### ADDENDUM NO. 1

MILHAM WATER TREATMENT PLANT UPGRADES

CONTRACT 2015-13

**E-101**

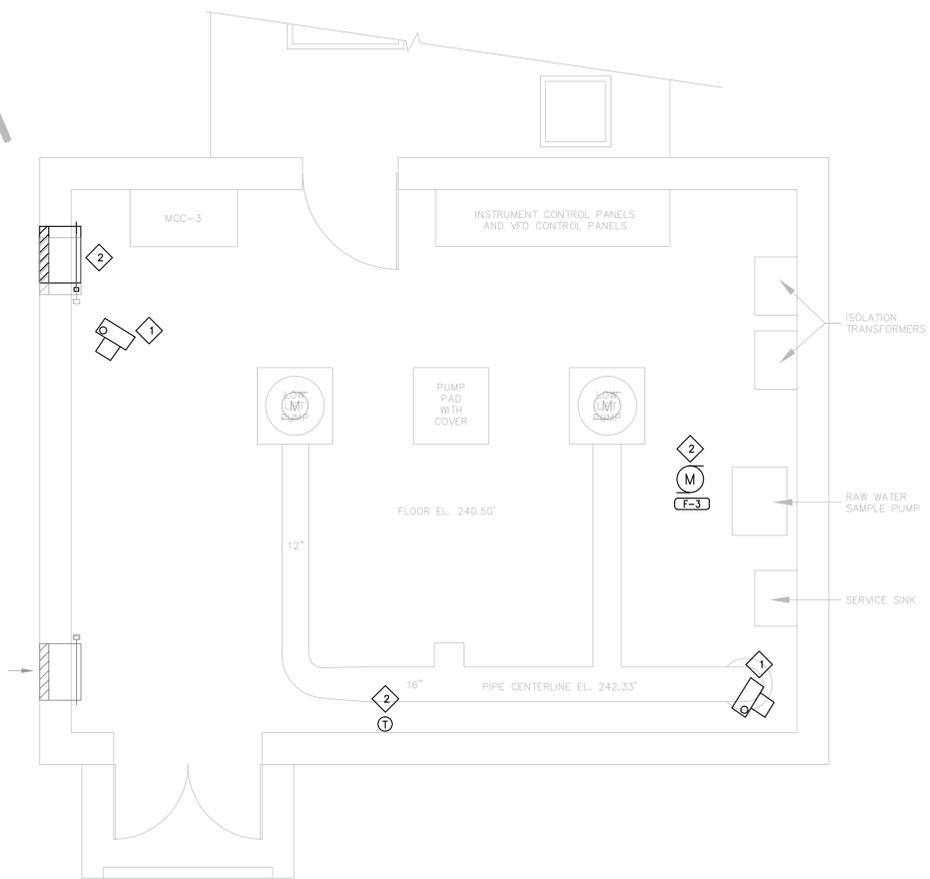
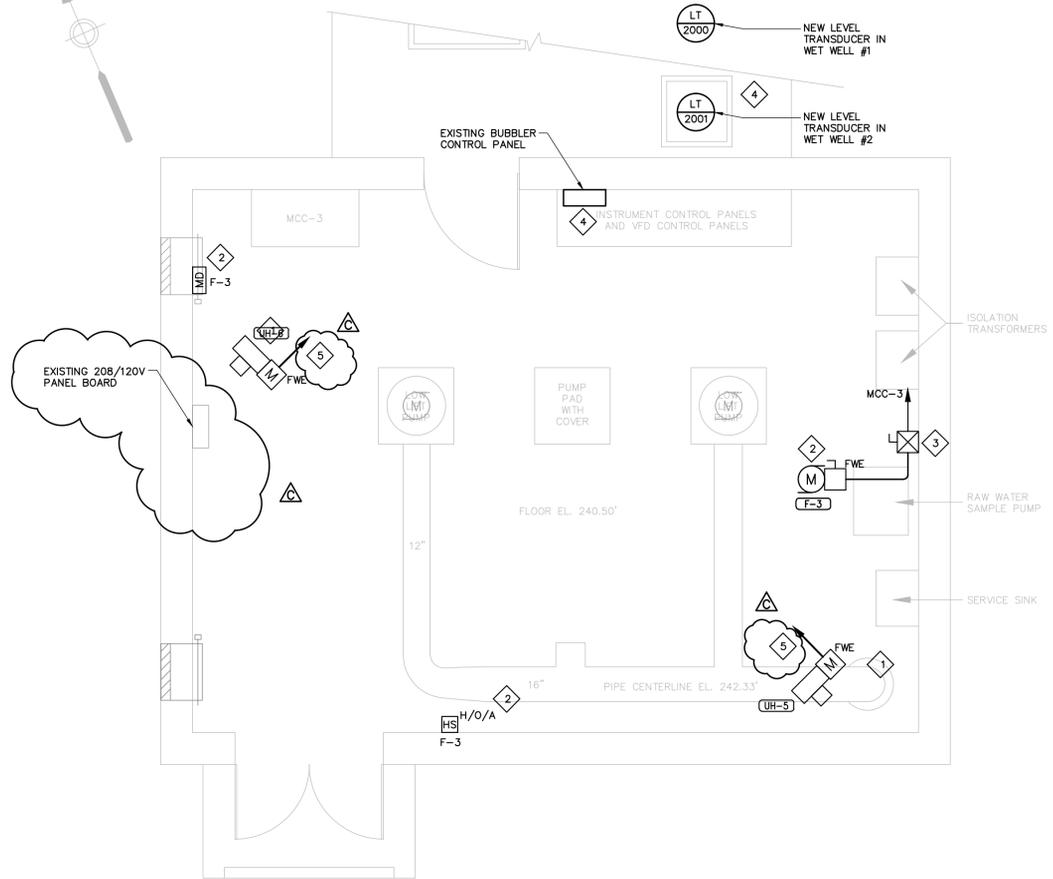
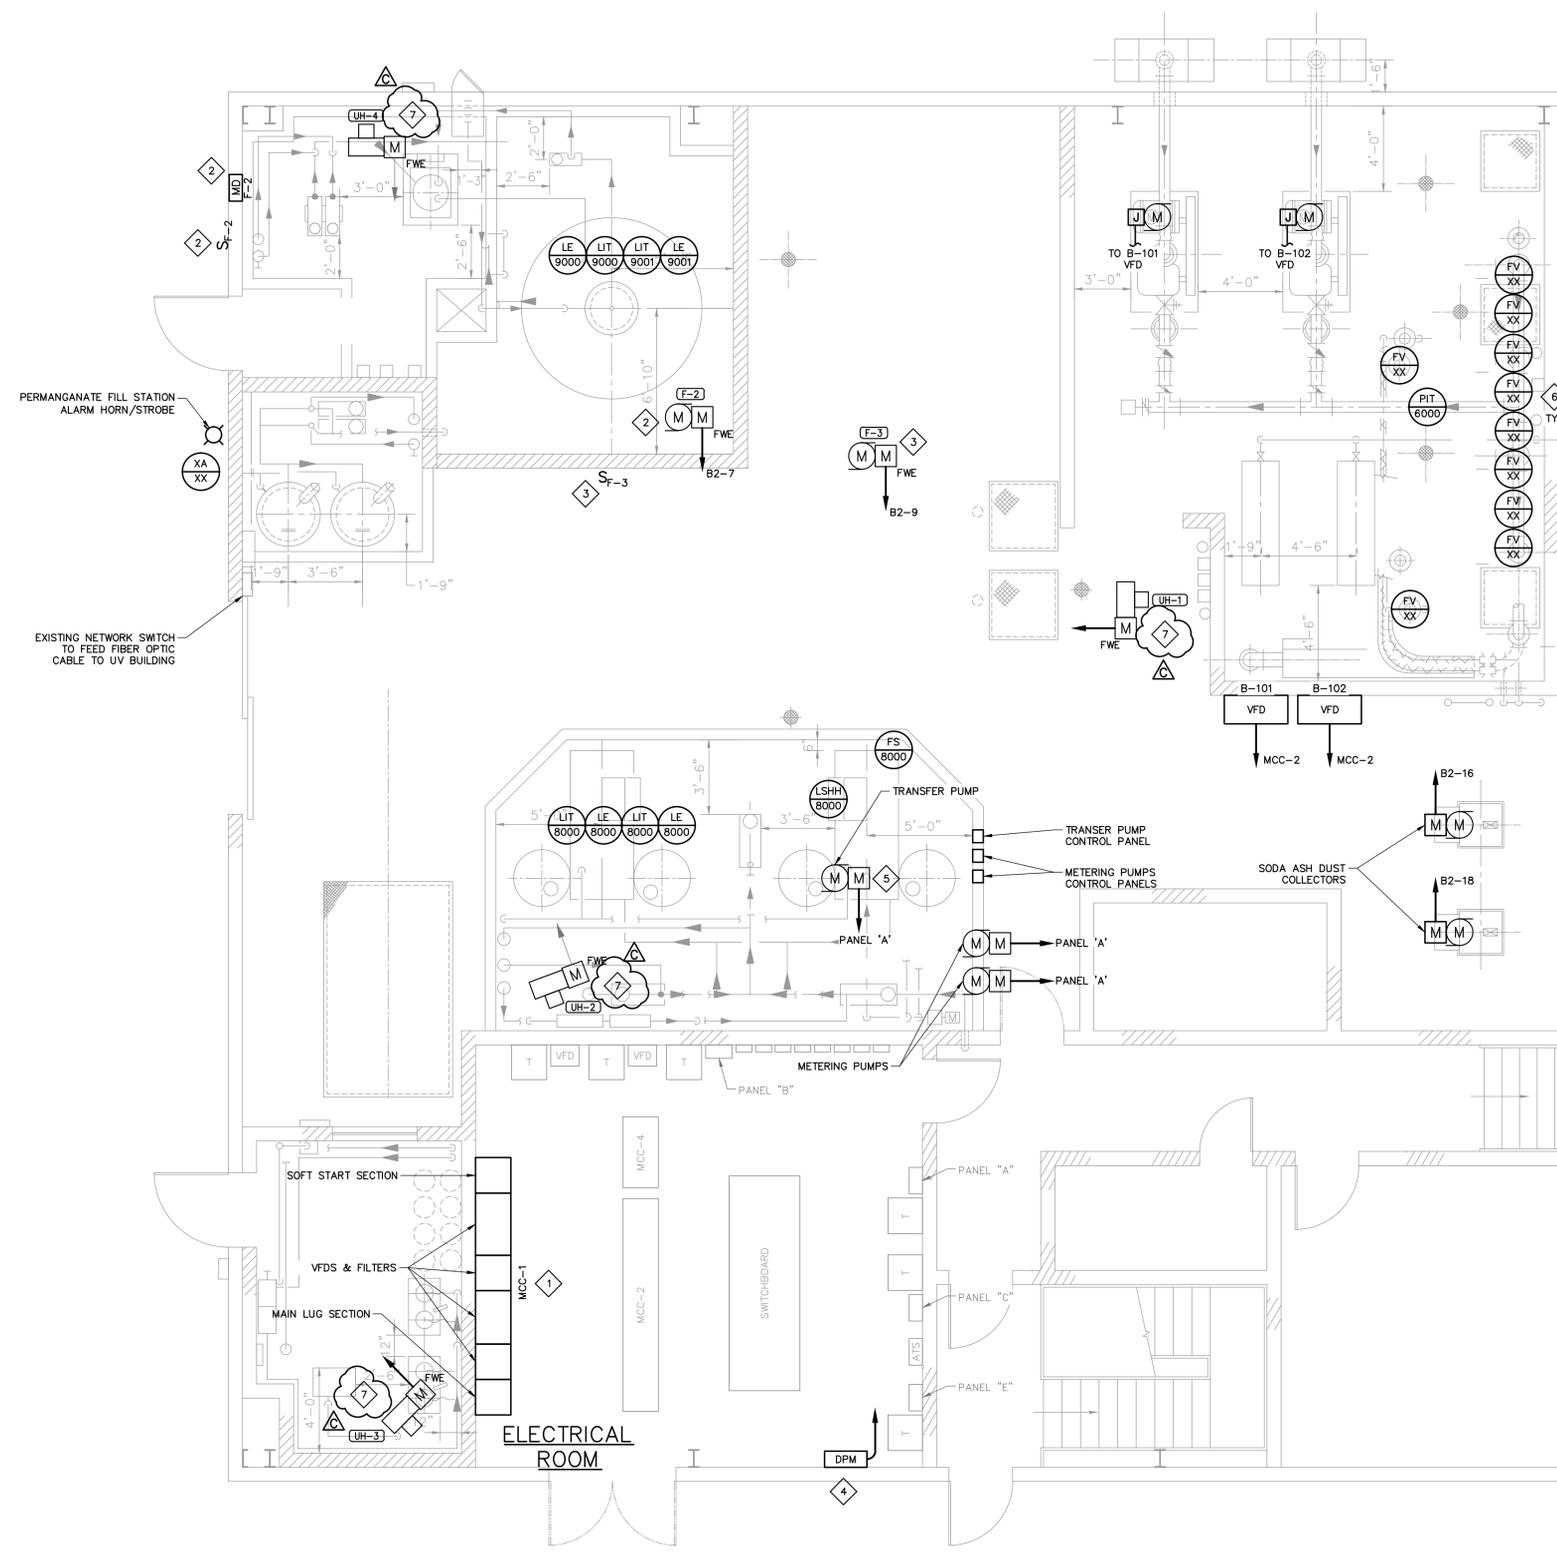
*Is there electrical work required for the new HVAC equipment in the Pump House?*

Answer: Yes. Refer to Drawings E-101 and E-602 reissued as an attachment to this Addendum (Addendum No. 1) for further clarification.
